APPENDIX C6
COMMENTS RECEIVED

Comments received on EIA Report to be included
in the Final EIA Report

ACCEPTANCE OF THE FINAL SCOPING REPORT FOR THE PROPOSED ZIONSHEUVEL SOLAR PV FACILITY AND ITS ASSOCIATED ELECTRICAL INFRASTRUCTURE ON REMAINDER OF FARM LEEUWBERG 79 IN THE RENOSTERBERG LOCAL MUNICIPALITY NORTHERN CAPE PROVINCE

COMMENTS ON THE DRAFT SCOPING REPORT FOR THE PROPOSED ZIONSHEUVEL SOLAR PHOTOVOLTAIC (PV) FACILITY AND ITS ASSOCIATED ELECTRICAL INFRASTRUCTURE ON REMAINDER OF THE FARM LEEUWBERG 79 IN THE RENOSTERBERG LOCAL MUNICIPALITY IN THE GREATER PIXLEY KA SEME DISTRICT MUNICIPALITY, NORTHERN CAPE PROVINCE.

Zionsheuvcl Solar PV Facility Crossroads Green Energy Cluster Northern Cape Province

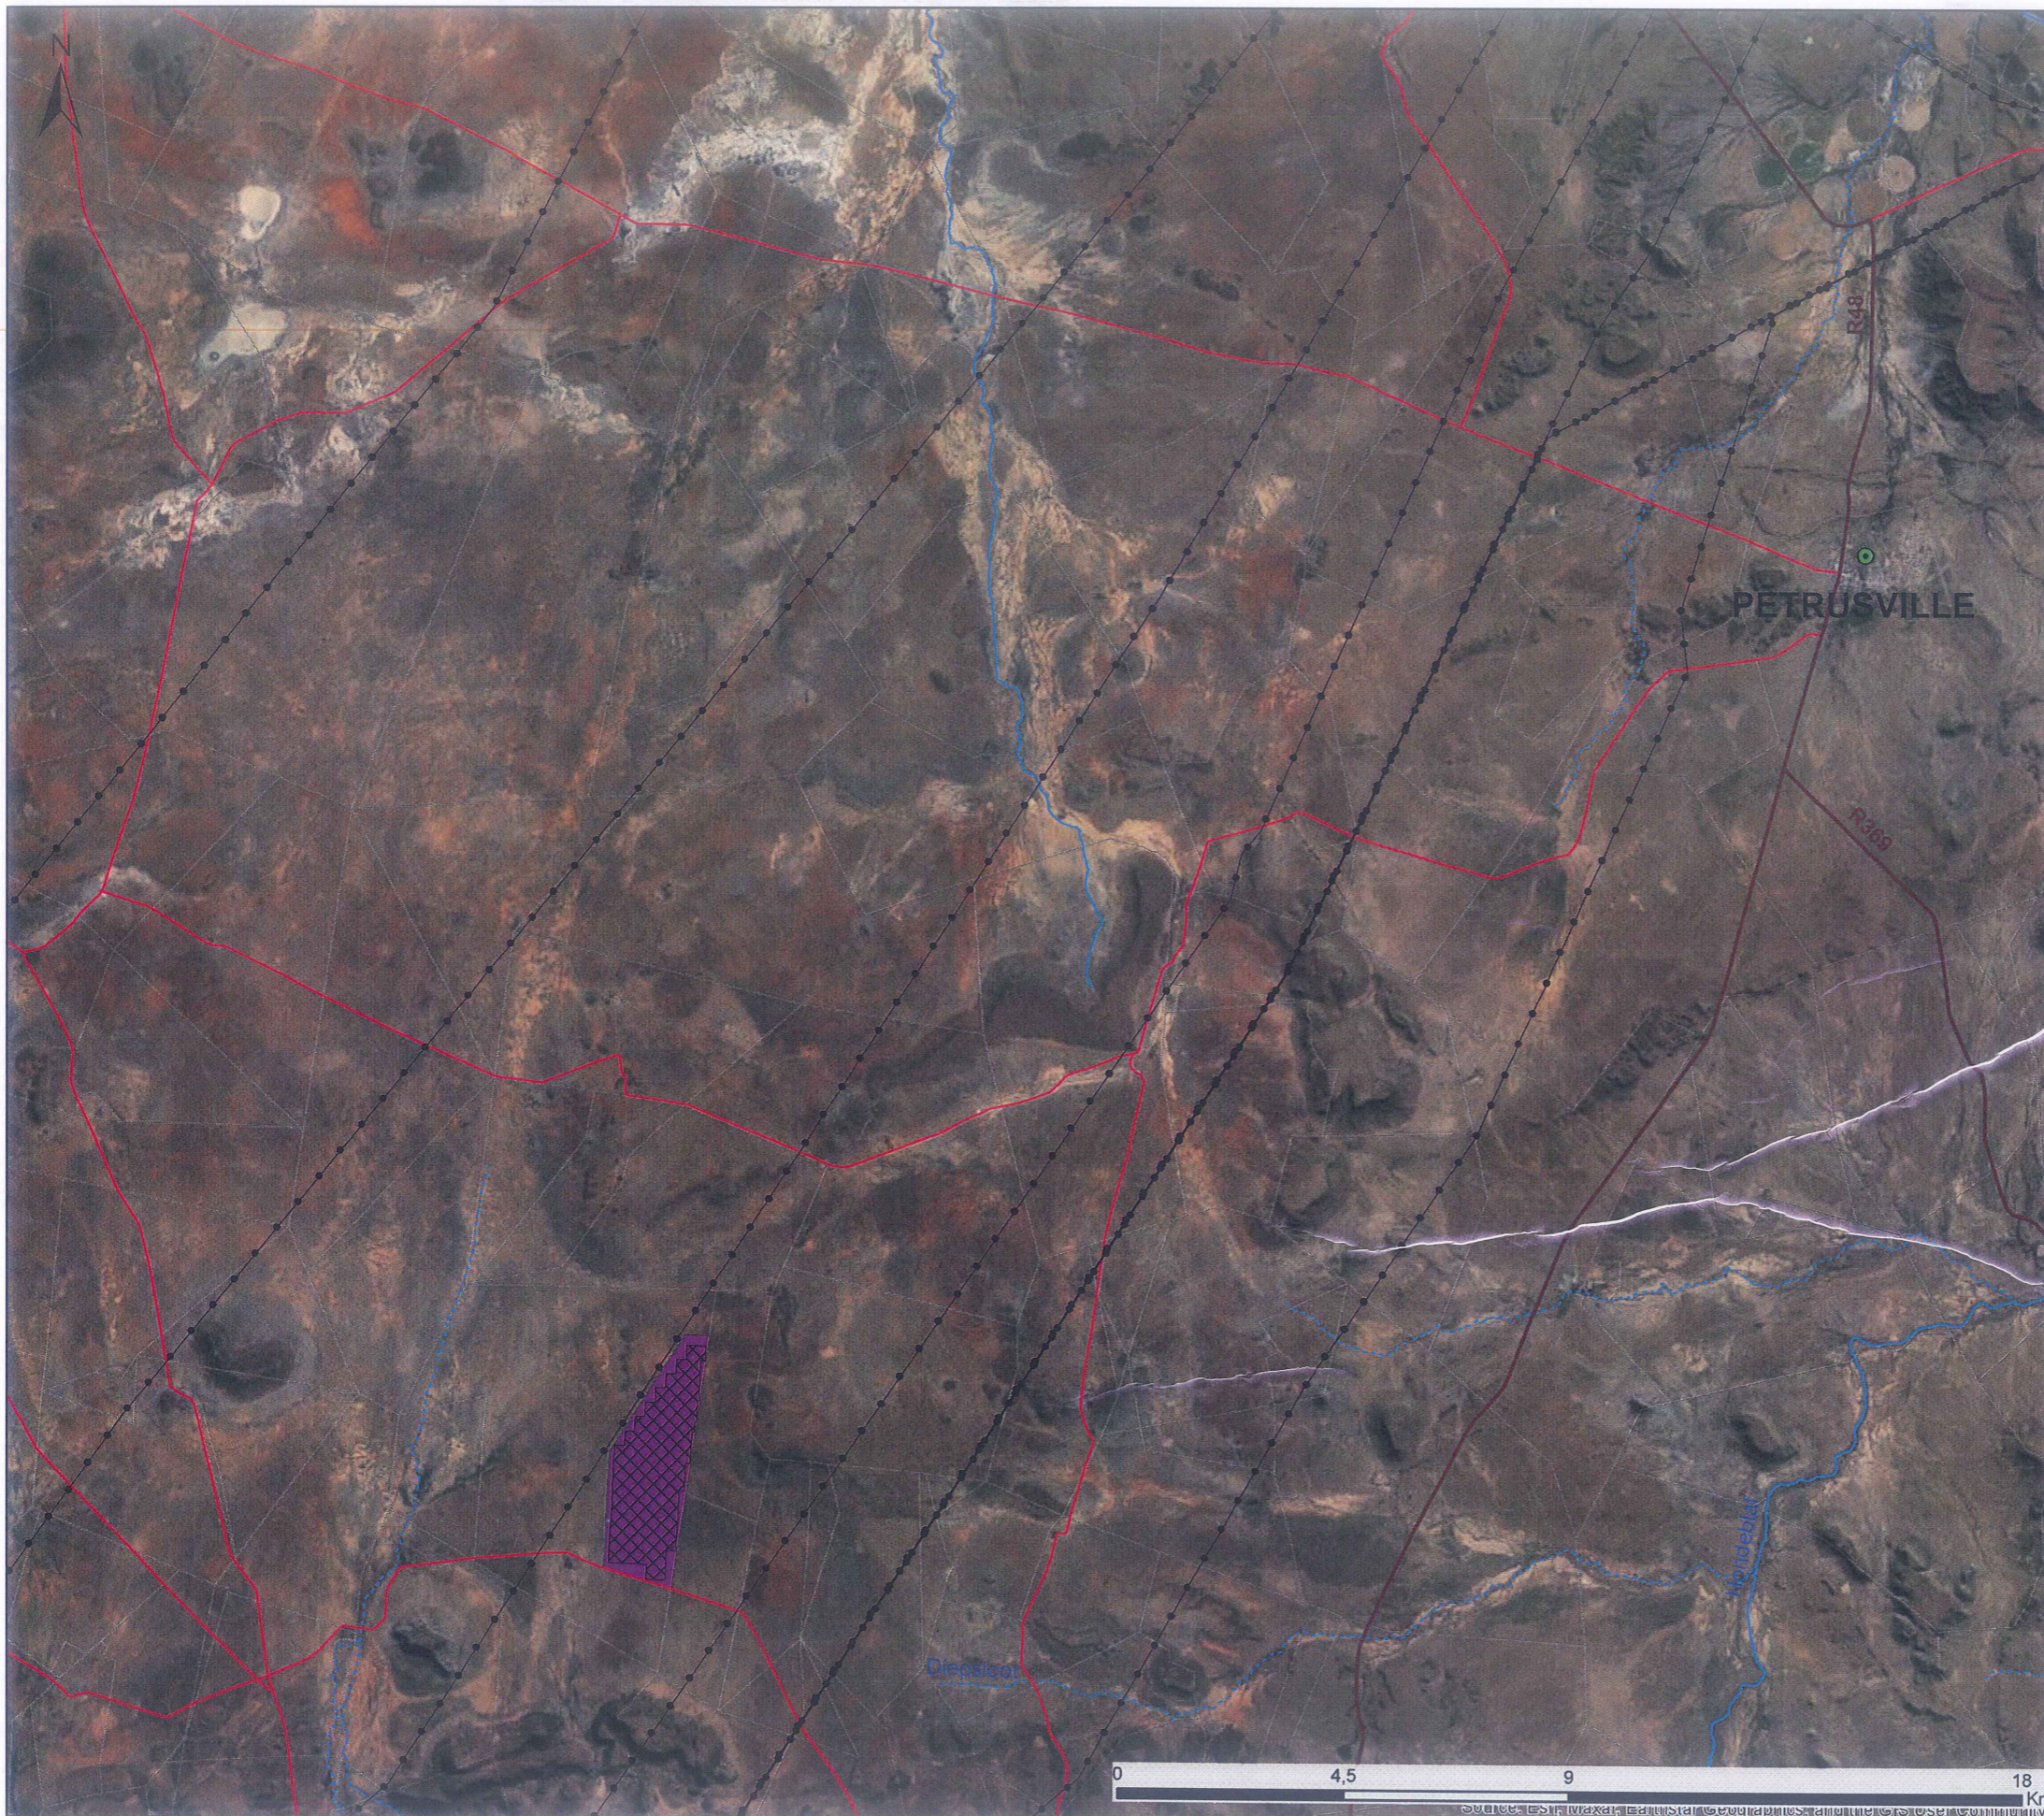
TELKOM SA. LIMITED DECLARATION
 NO COMPANY PLANT IS AFFECTED BY
 THIS PROPOSAL.

Aerial Plant - At points of crossing, the overhead power lines should cross above the communications lines in accordance with and clearances stipulated in the Occupational Health and safety Act no 85 of 1993, Machinery regulations 20 – Crossings, and Electrical Machinery Regulations 15 – Clearance of Power Lines. If the specifications could not be met, all deviation costs will be for the applicant's account. We also refer to section 25 of Electronic Communication Act 36 of 2005.

The crossing of supply lines or overhead service mains directly above or adjacent to communication poles must be avoided if possible. If not clearance of **3** meters must be provided.

Paragraph 2.4.1 of the Code of Practice stipulates the minimum acceptable horizontal separation between power and the communication lines and where this cannot be met, the design of the power line is also stipulated. This could apply between the attached plans and these requirements should strictly be adhered to.
